Interactive comment on “Automatic high-frequency measurements of full soil greenhouse gas fluxes in a tropical forest” by Elodie Alice Courtois et al.

Elodie Alice Courtois et al.

Received and published: 9 November 2018

Figure 1: Daily temperature variation at 2m height under the canopy cover during the study period (June-September 2016).

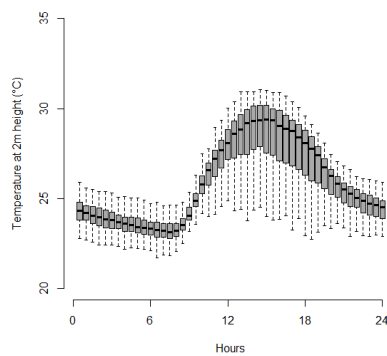
1. How did the authors keep moisture from affecting sampling, either within the tubing lines or when moving from IRGA to Picarro? Was there any moisture buildup in the tubing lines?

Response: We also worried about moisture problems prior to our experiment, but such problems never occurred. No significant condensation occurred in our system, we assume because temperature variations were typically small below the canopy, varying from 22°C in the night to 28°C during the day (see Figure attached). We regularly checked that no liquid water accumulation occurred in the sampling tubes. Moreover, both analysers measure water vapor and account for its effect on concentration of CO₂, CH₄ and N₂O .

Changes in the manuscript: Temperature variations are typically small below the canopy due to the shadowing by dense canopy crown and microclimatic conditions. During the study period, temperature at 2m height varies during the day from 22 °C in the night to 28 °C during the day. The presence of water condensation inside the tubing lines was carefully checked every week and never occurred during the study period.
